Agenda
Village of Arlington Heights
Design Commission
Community Room, 3rd floor
Arlington Heights Village Hall, 33 S. Arlington Heights Rd.
September 24, 2019
6:30 PM

**Design Commission
9/24/2019**

MINUTES OF
THE VILLAGE OF ARLINGTON HEIGHTS
DESIGN COMMISSION MEETING
HELD AT THE ARLINGTON HEIGHTS MUNICIPAL BUILDING
33 S. ARLINGTON HEIGHTS RD.
SEPTEMBER 10, 2019

FRONT ELEVATION

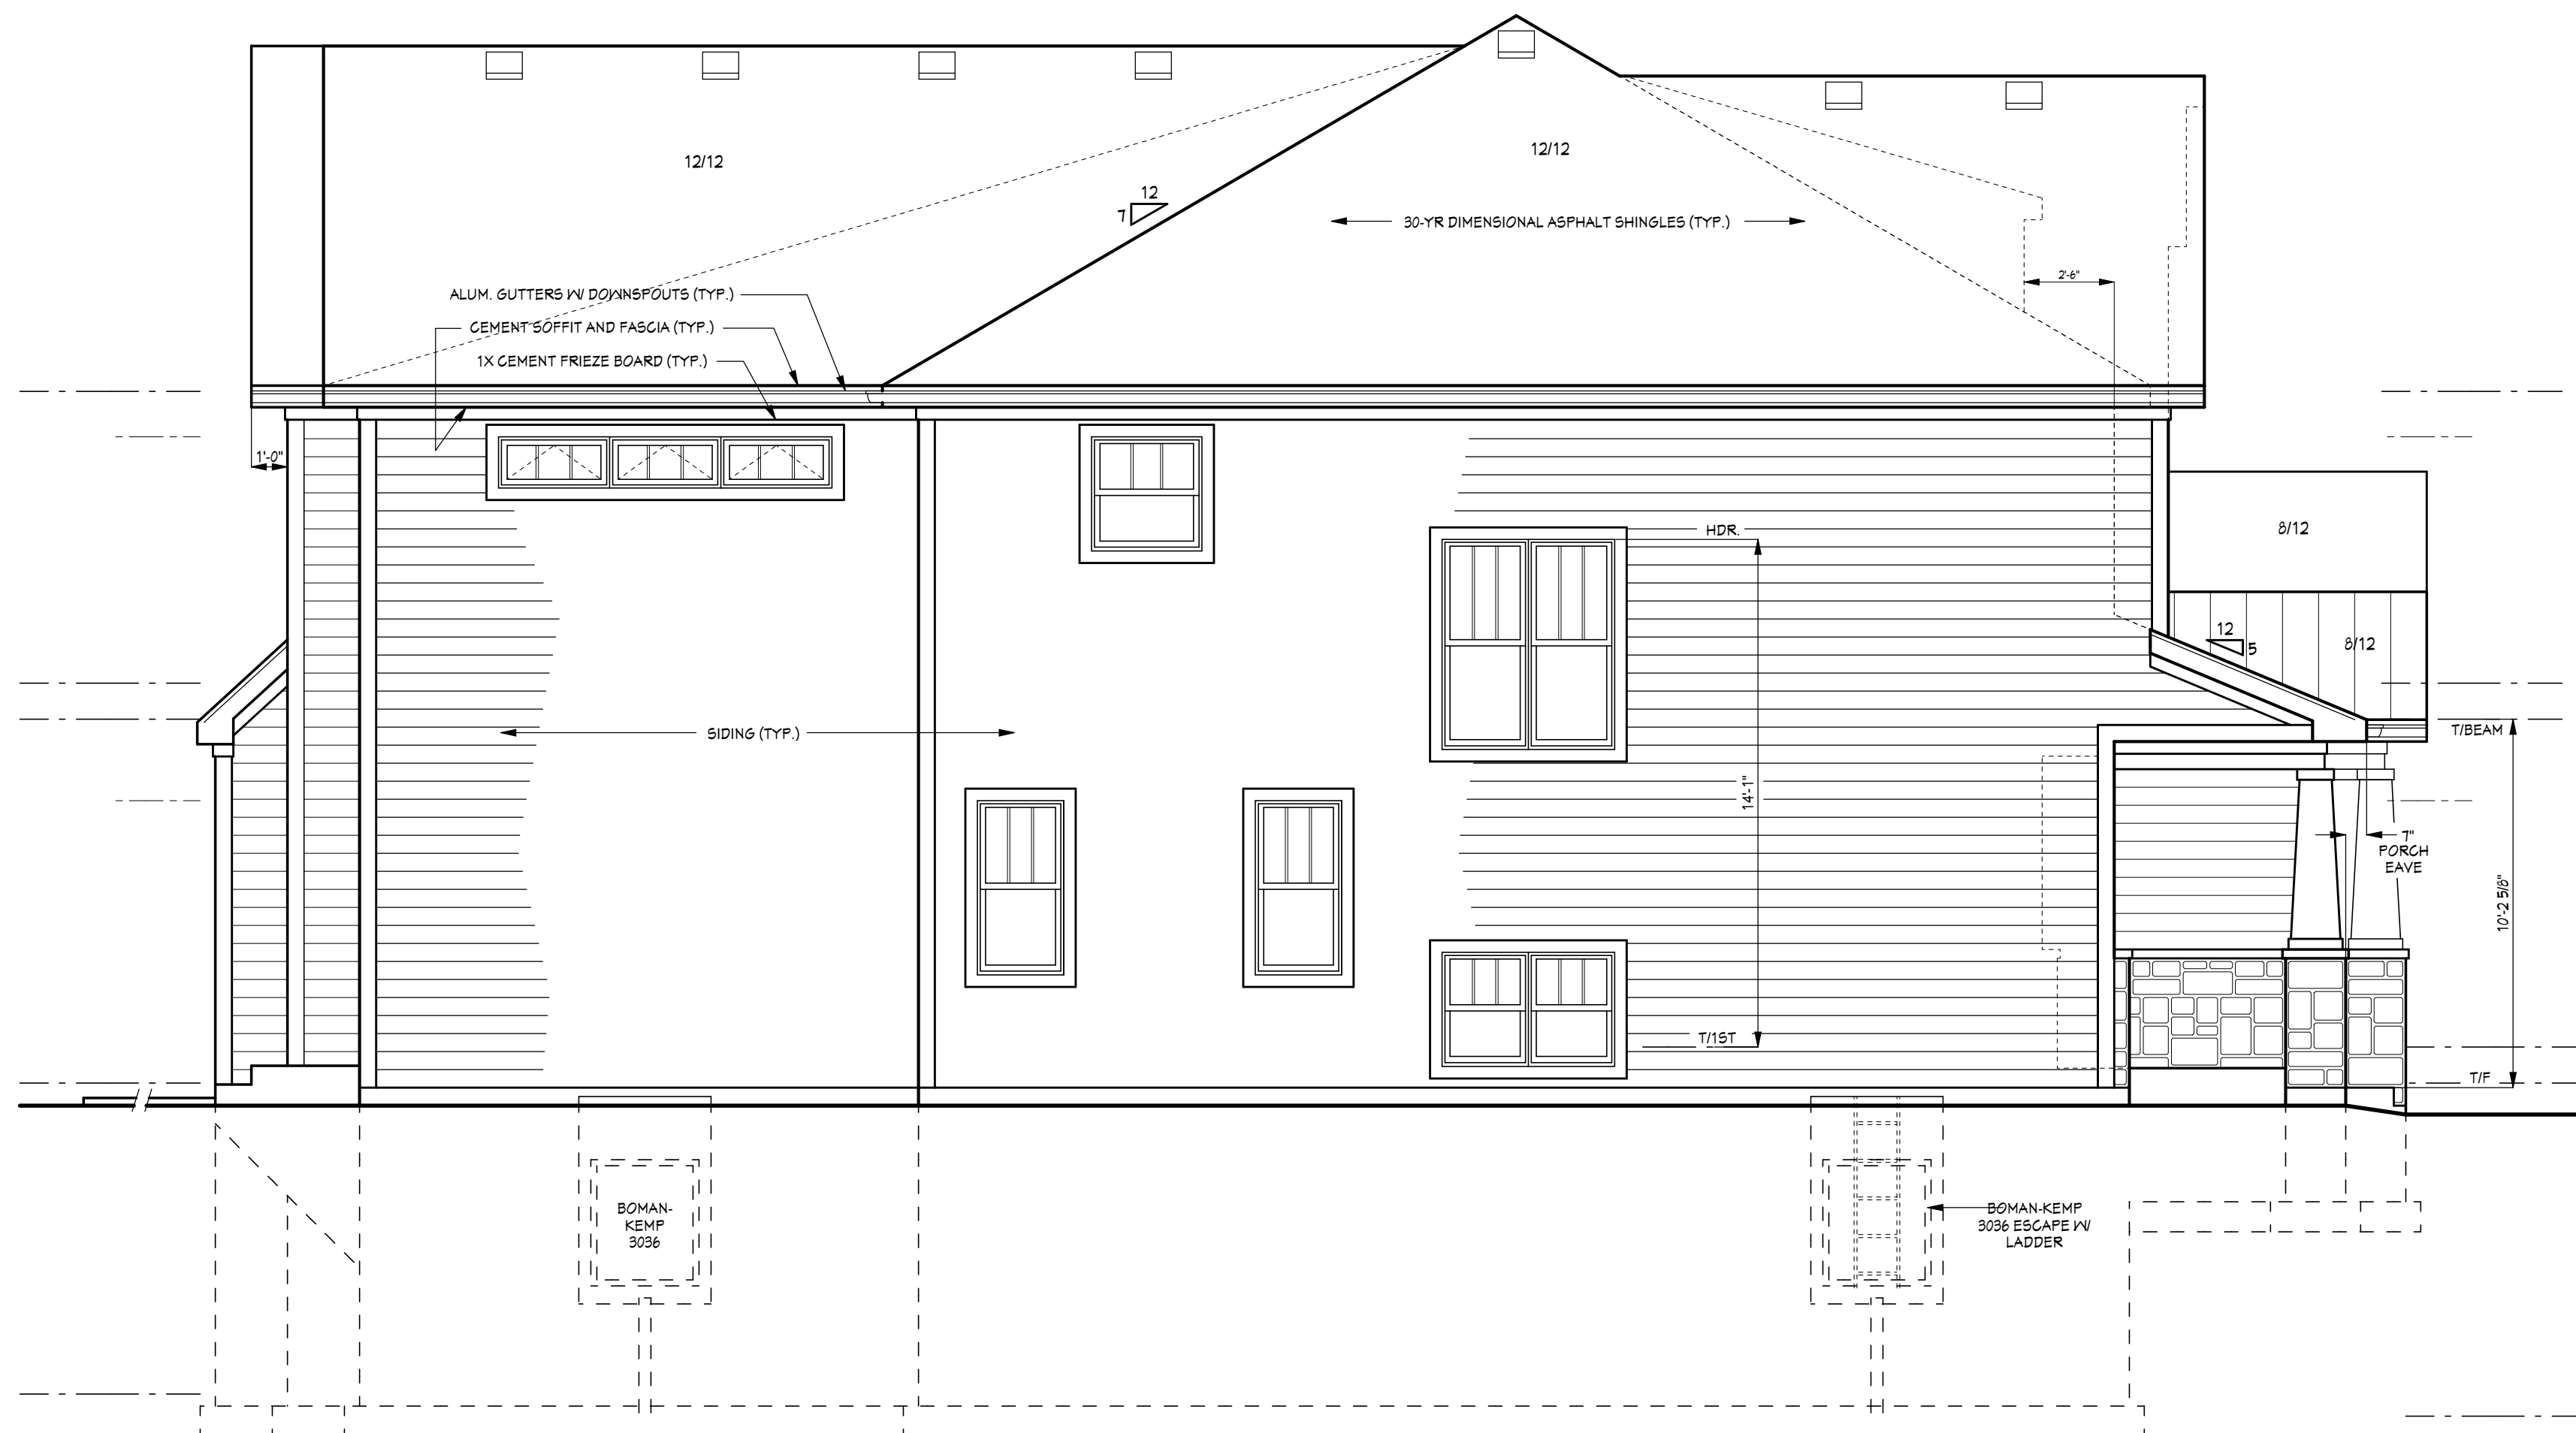
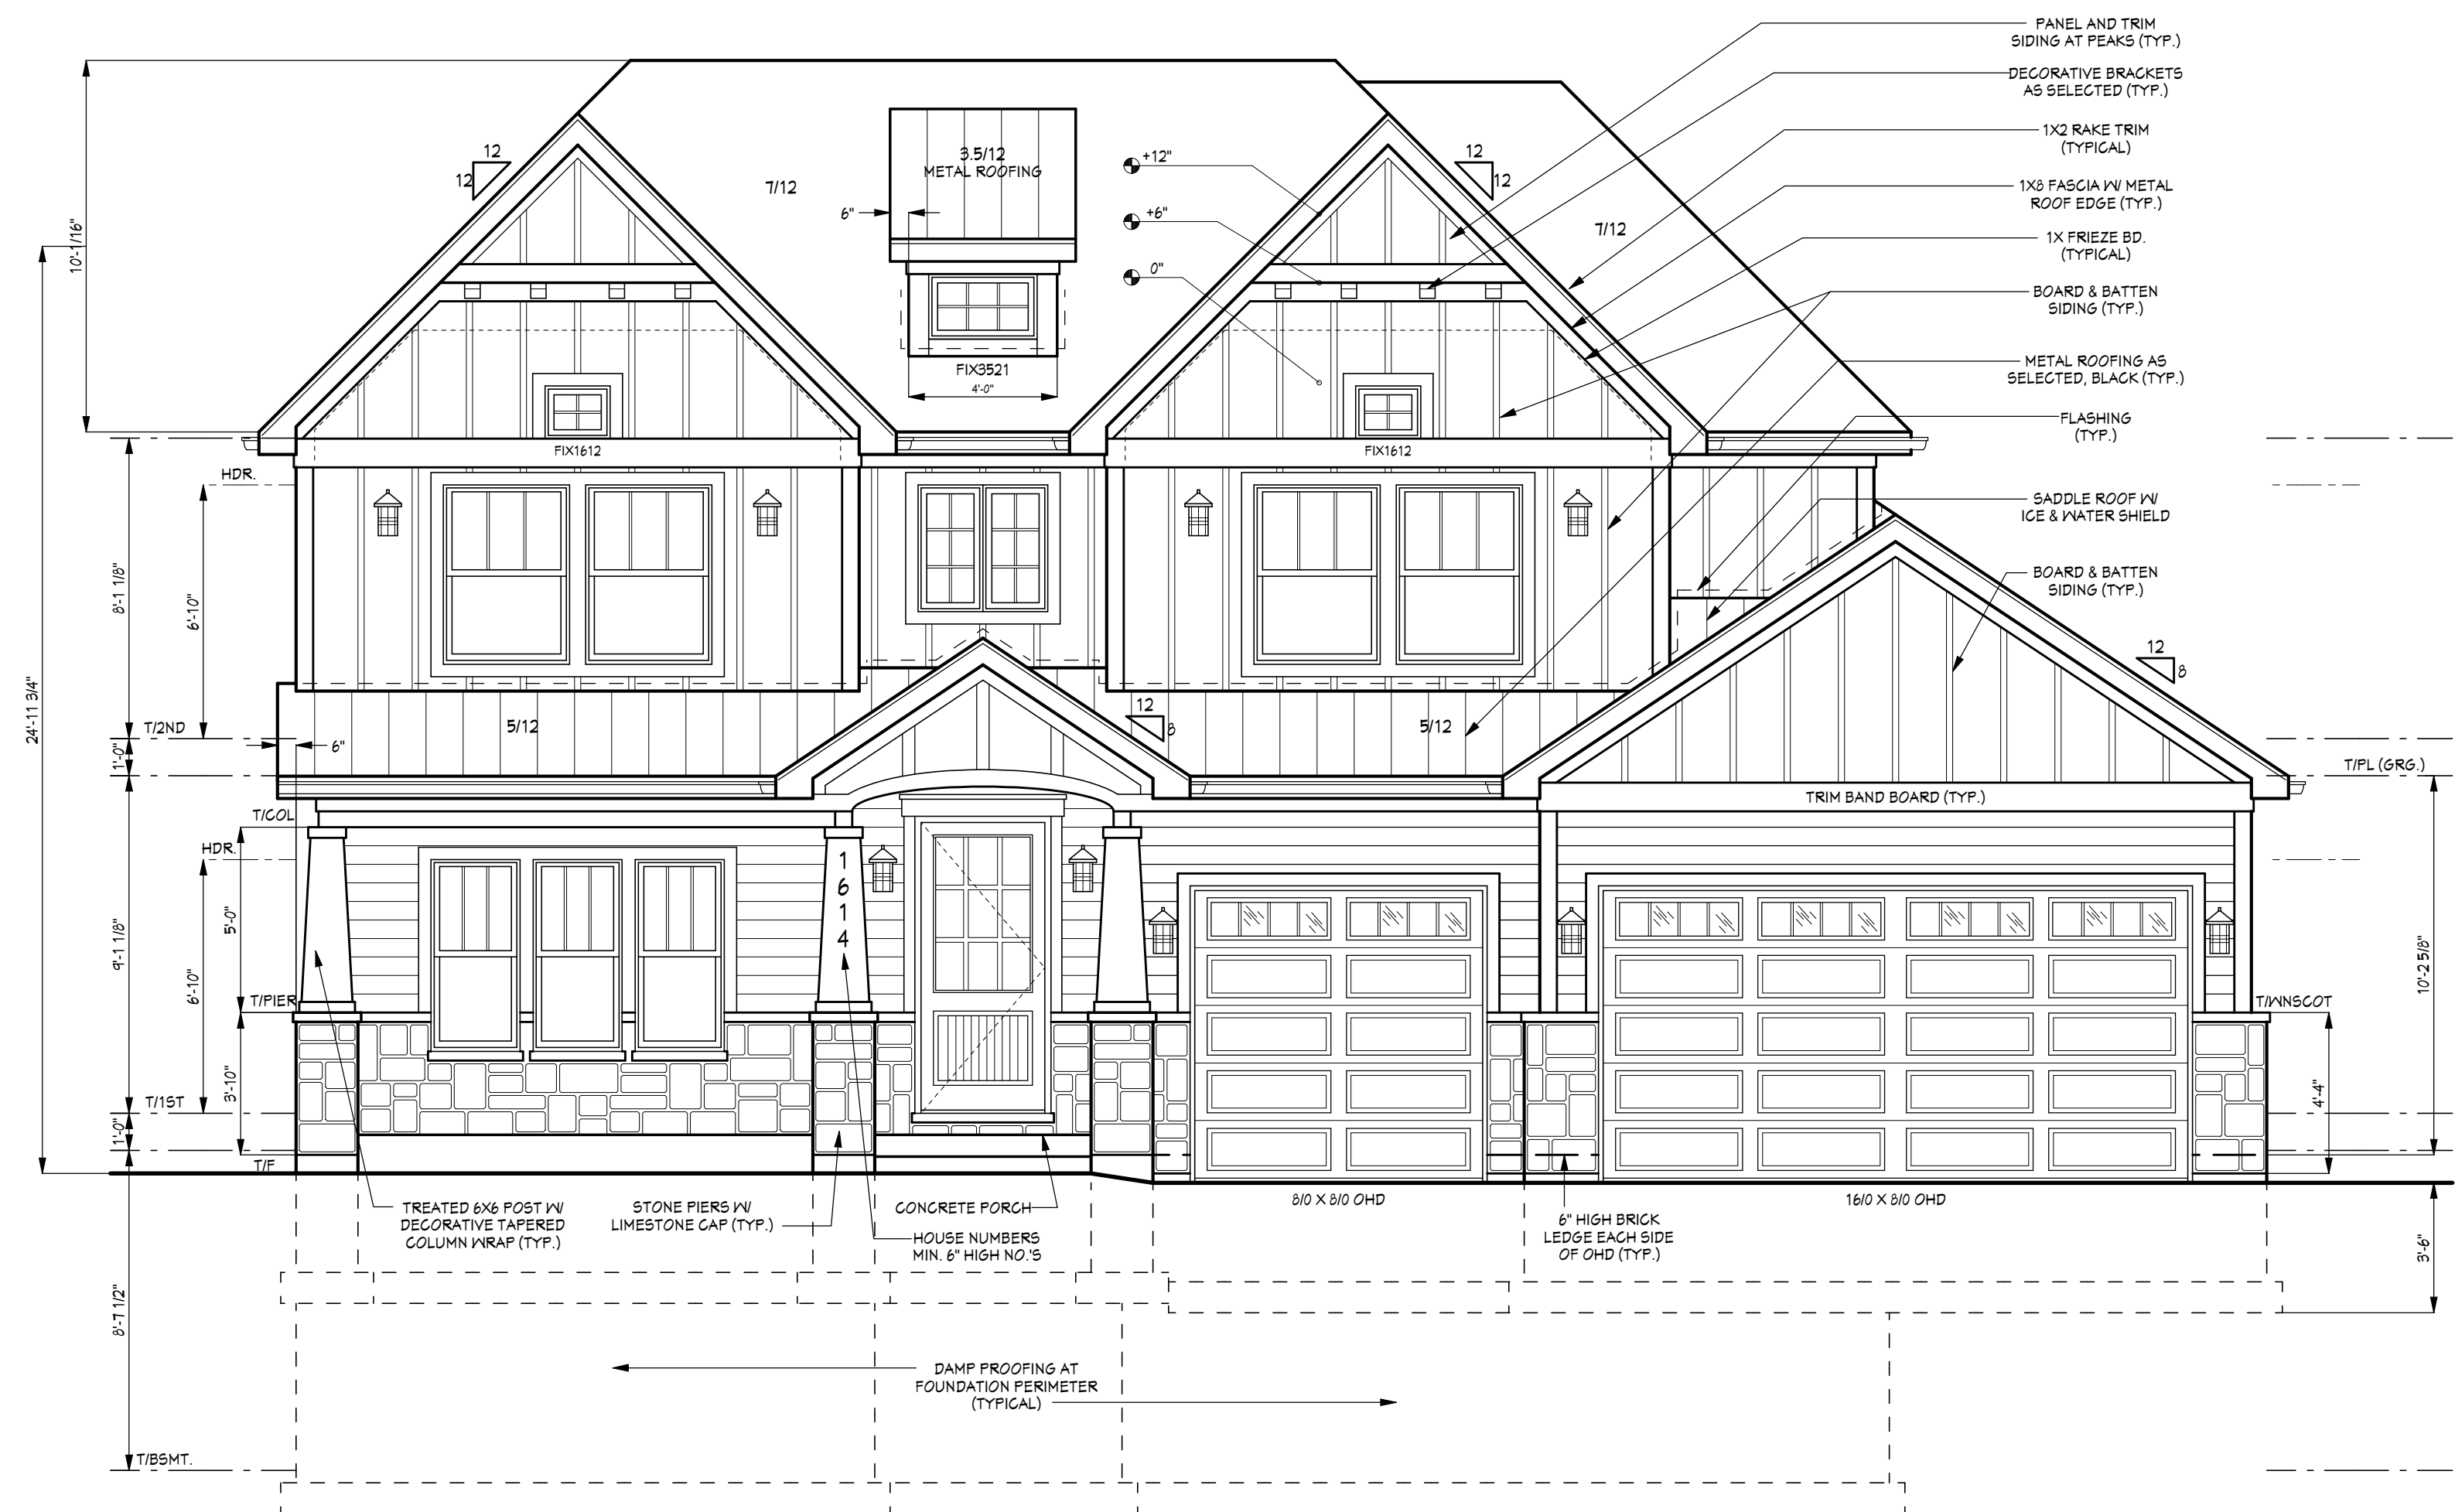
- Evaluate and coordinate the proportions of the windows throughout the design.
- Change the stone masonry to brick to better fit with the context of the neighborhood.

- Extend the masonry base down the side walls for a more cohesive level of detail on all sides of the house.
- Change the black fascia and soffits to white to better fit with the context of the neighborhood.

- Show the locations of all downspouts so that the black versus white color can be evaluated.
- Add a small roof above the back patio door.

- Reduce the pitch of the upper gables and main roof from 12:12 to 8:12 to reduce the overall mass of the roof. An 8:12 roof pitch would coordinate with the 8:12 pitch on the garage roof and the front porch entry gable.
- Omit the dormer on the roof to eliminate the appearance of a third floor.
- Change the stone masonry to brick to better fit with the context of the neighborhood.
- Extend the masonry base down the side walls for a more cohesive level of detail on all sides of the house.
- Change the color of the gutters and downspouts from black to white to better fit with the context of the neighborhood.

- The eave height of the first floor porch and garage roof has been lowered to better align with the adjacent houses.
- The exterior lights at the second floor have been omitted.
- The black fascia and soffits have been changed to white.
- A small roof has been added above the back patio door.

The builder shall revise the soffit and fascia color to white. The gutters and downspouts better fit the architectural style and modern farmhouse color scheme to remain in black (as previously approved and constructed at 1702 N Verde).

- The second story exterior lights at the front elevation have been deleted
- A bracketed roof has been added at the rear patio door

1 EAST ELEVATION
1/4" = 1'-0"

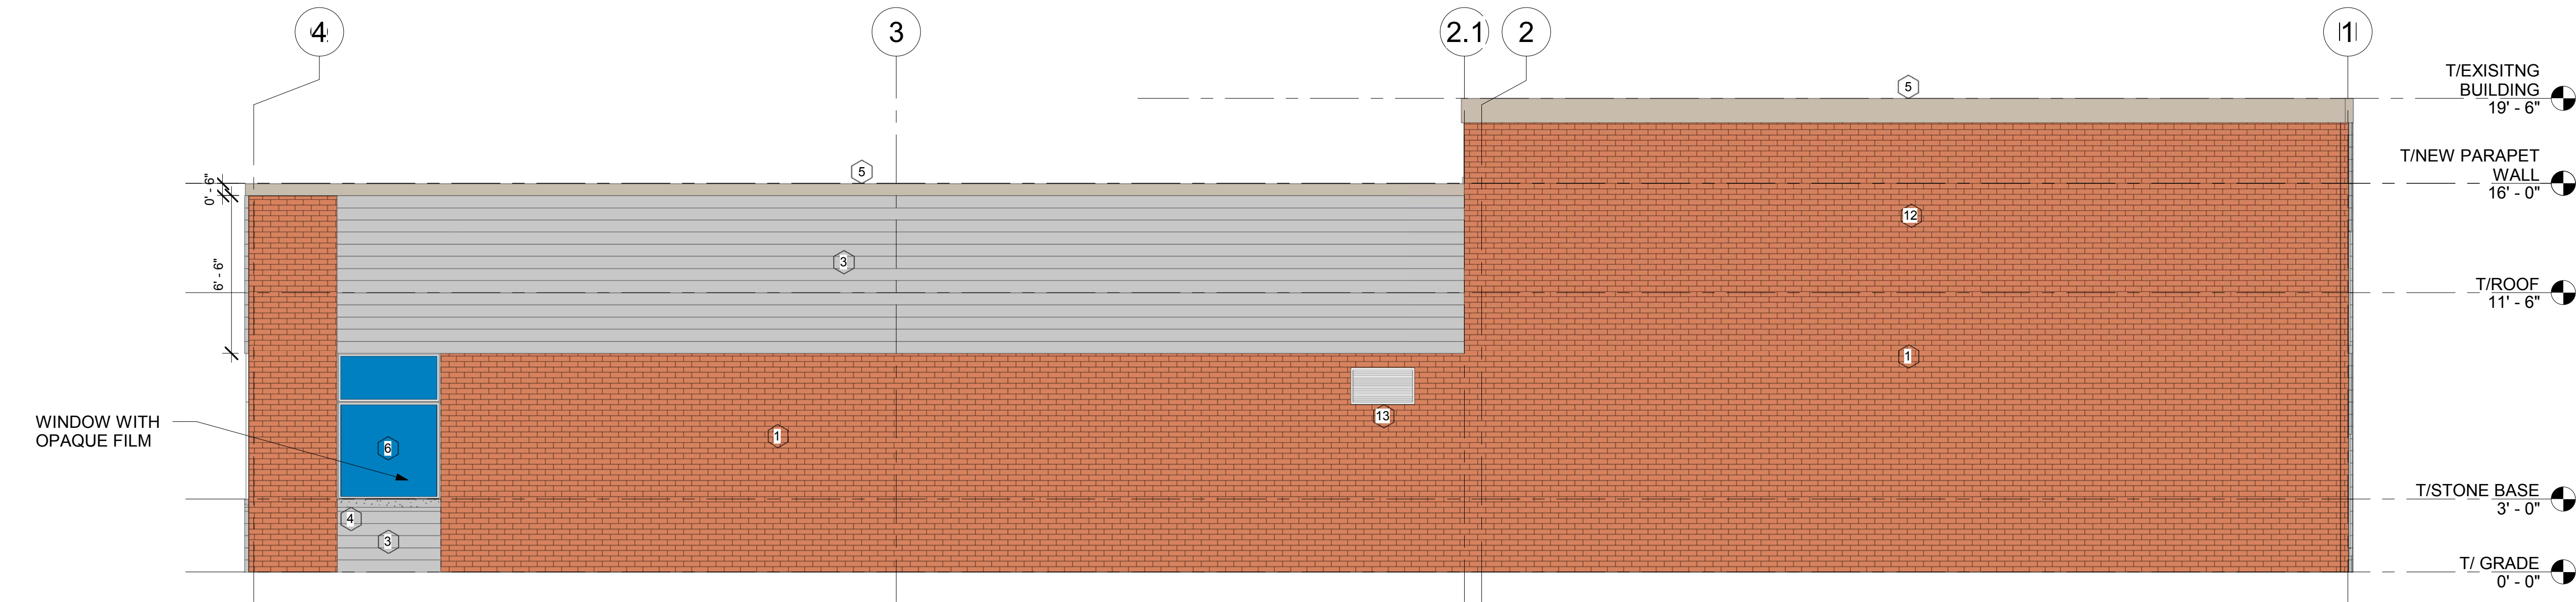
Commissioner Kingsley said there would be hurdles to create a front facade that has a little more relief in it than what is currently proposed, which is just a straight wall and straight coping with everything flush. She felt the front facade would benefit from some kind of relief and wanted to see the project come back for another review after some kind of relief was added to the east facade to make it more inviting. She also pointed out the location of patient chairs inside the windows along the east elevation and suggested a different window tint or a brise soleil with a simple sun shade that would help with sun protection for patients in those chairs.

for him. He agreed with the concerns about the stone on the front elevation and suggested taking the stone below the windows and going more horizontal across the building with it, instead of the horizontal and vertical detail being proposed.

Looking at the foundation plans, Commissioner Kingsley pointed out that the existing foundation wall is only under the north half of the east wall, so the south half could be stepped back to 1 to 3 feet to add some kind of 3-dimensional relief or shadow line on the front of the building. Mr. Florczak said they could work on creating a recess on the front of the building by moving the window system farther, and pointed out that the entire inside space along the east side of the building is an open bay treatment area with dental chairs, which requires specific dimensions, and the space there is tight, which is the reason for the proposed expansion. Accommodating a canopy on the east elevation that would result in the building being moved, would probably not be attractive to the client; however, they want to address this request by creating some type of reveal above the windows.

Mr. Florczak said they could remove the stone on the east elevation and bring the brick piers down to the ground, and raise the brick piers up through the metal paneling above, similar to the south elevation, and then add an aluminum channel for signage that would wrap around the corner.

- b. ELIMINATE THE STONE BASE AND CONTINUE BRICK PIERS DOWN TO THE EXISTING AND THE NEW FOUNDATION.
2. A REQUIREMENT THAT AN ABUNDANCE OF SALT AND DROUGHT TOLERANT SHRUBS, ORNAMENTAL GRASSES, AND OTHER PERENNIALS BE PROVIDED IN THE PLANTING BED ALONG THE SOUTH BUILDING WALL AND FACING ARLINGTON HEIGHTS ROAD.
